Memo

From	Richard Measures
To	Karen Wilson, Environment Southland
CC	Hugh Robertson and Nicki Atkinson, Department of Conservation Chris Jenkins, Environment Southland
Date	21 November 2024
Subject	Review of Waituna Lagoon water balance modelling

Figure 1: Validation of model ability to reproduce observed lagoon water levels during closed periods (lagoon water level during open periods not shown).

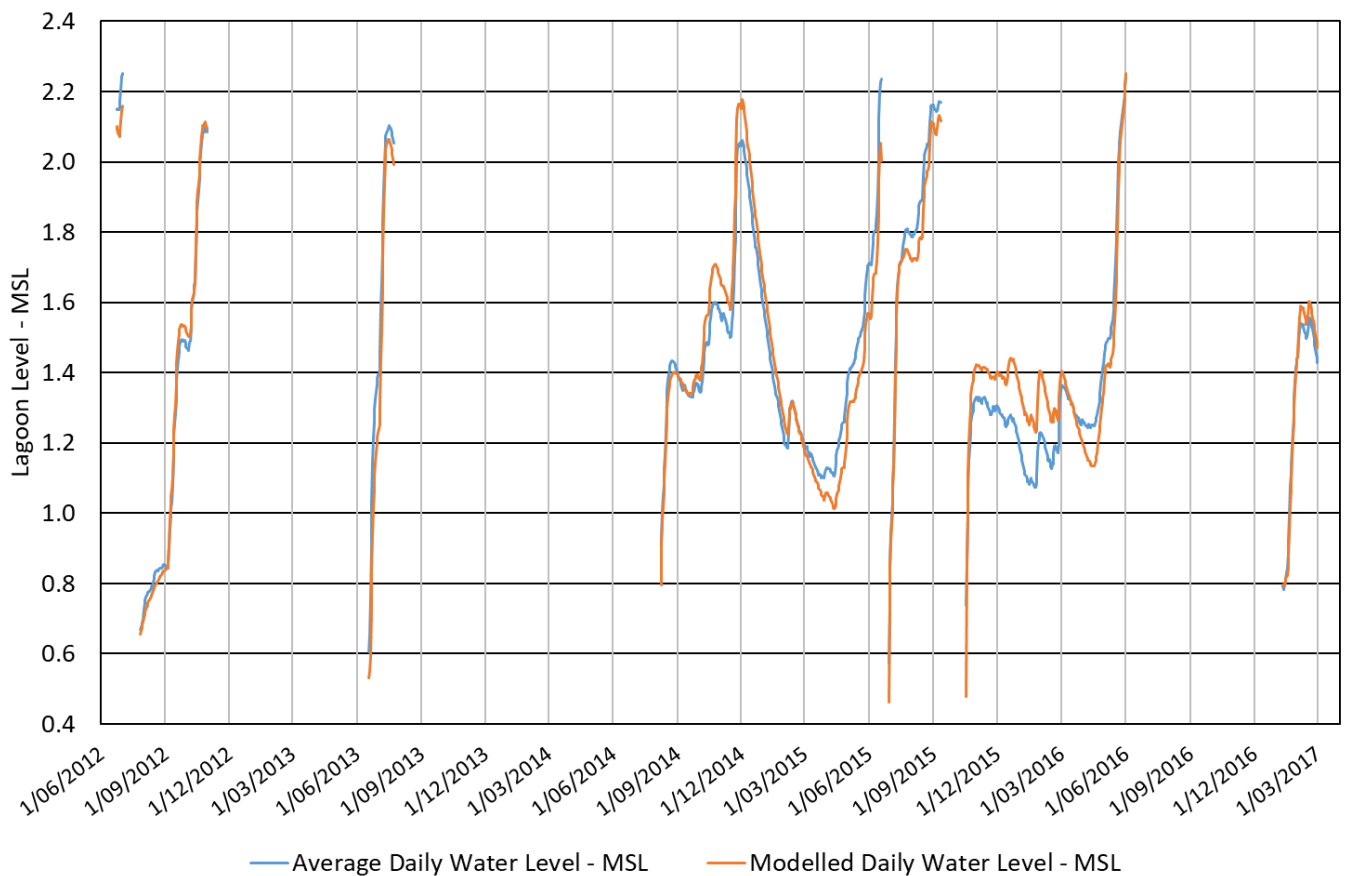
Validation of the barrier seepage and groundwater inflow components was carried out by simulating the period from 2012 to 2017 (i.e., separate from the period used for calibration) and comparing the modelled and simulated lagoon water levels during closed periods (actual opening and closure dates were used in the model). These validation results are shown in Figure 1. Further validation for the period Jan 2017 to June 2023 is presented in the consent application (Figure 18 of the application).

Overall, the model validates well for both periods, indicating high confidence in the water balance calculation during closed periods.

Figure 2: Potential changes in barrier seepage following summer 2023–24.

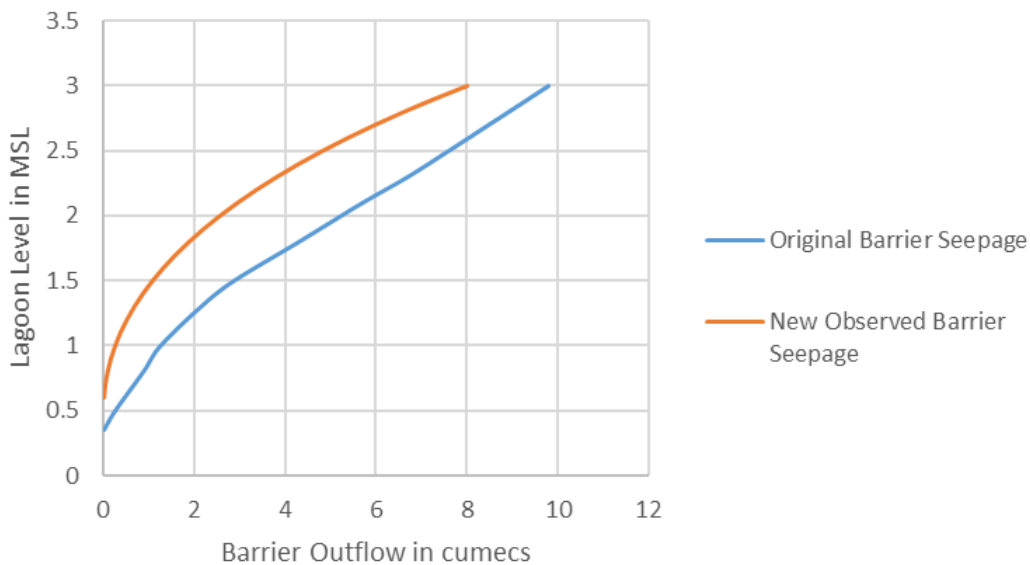
The Waituna Lagoon model is automatically run in real-time by ES and, following summer 2023–24, observed and modelled lagoon water levels have diverged. Potential causes of this divergence are increased total catchment inflow into the lagoon relative to recorded flows (e.g., due to rating curve errors), or that the relationship between barrier seepage and lagoon water level may have changed. Preliminary investigations by Chris Jenkins suggest that the barrier seepage may have changed, and an initial estimate of a new barrier seepage function has been developed (Figure 2) which results in improved model performance for 2024. The new seepage curve is highly uncertain, particularly for low to medium lagoon levels due to the short duration the lagoon has spent closed at levels below 2.2 m (following closure of the lagoon on 30 March 2024 the lagoon rapidly filled to approximately 2.3 m and stayed at high levels until it was opened in September 2024). In the future, once more data are available, the new seepage function will likely be able to be refined.

Based on the newly calibrated barrier seepage function it appears that seepage has reduced by an approximately uniform value of around $2 \text{ m}^3/\text{s}$ for lagoon levels from 1.5 to 2.5 m (seepage values for lagoon levels above $\sim 2.6 \text{ m}$ and lower than $\sim 1.0 \text{ m}$ were extrapolated as lagoon levels have not been in this range since the change). I find it surprising that the seepage function would change so uniformly, as I would expect a change in barrier porosity to cause a change in seepage proportional to depth (i.e., a change in slope of the outflow vs lagoon level relationship, reducing flows at all levels by a similar percentage, rather than a shift, reducing flows at all levels by a similar absolute amount). I understand that recent flow gaugings do not show major errors in the inflow gauging station rating curves, but the shape of the shift in the barrier seepage curve (noting that the lower part of the curve is highly uncertain) suggests to me that other potential sources of the divergence between modelled and observed levels should be further investigated.

Figure 3: Sensitivity of monthly-varying daily-probability of lagoon closure to changes in calculation methodology.

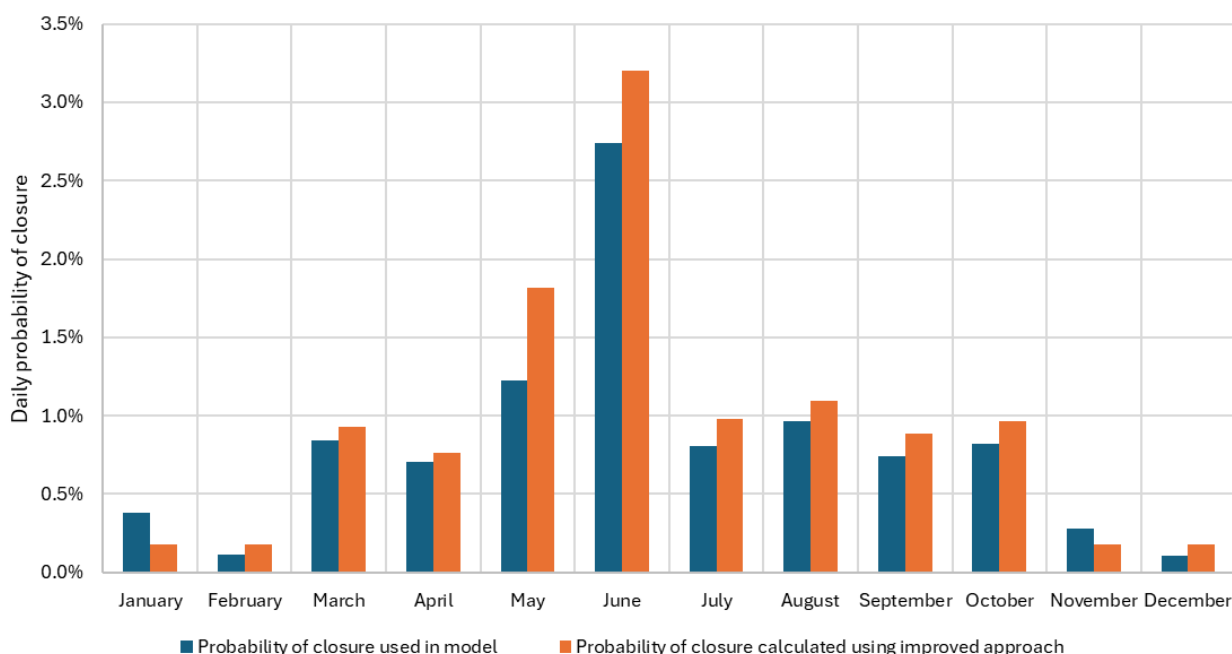
Figure 3 compares the monthly-varying daily-probability of closure used in the model against an updated calculation using the improved procedure described above (i.e., accounting for the number of days open in the month, and aggregating months with low numbers of observed closures). The changes to probability of closure are small for most months, although are more significant for May and January. To better understand the significance of these differences I calculated the effect on the probability of the lagoon closing at some point during each month assuming it was open at the start of the month (Figure 4). In general, the improved calculation method results in slightly increased probability of closure in most months, this would result in slightly shorter duration openings. The exception to this is the reduced closure probability in January and November. These are the result of aggregating across the November–February period, so are offset by increased probability of closure in December and February.

Overall, the differences in probability of closure as a result of improving the calculation are small and are unlikely to have significant effect on the conclusions of the modelling.
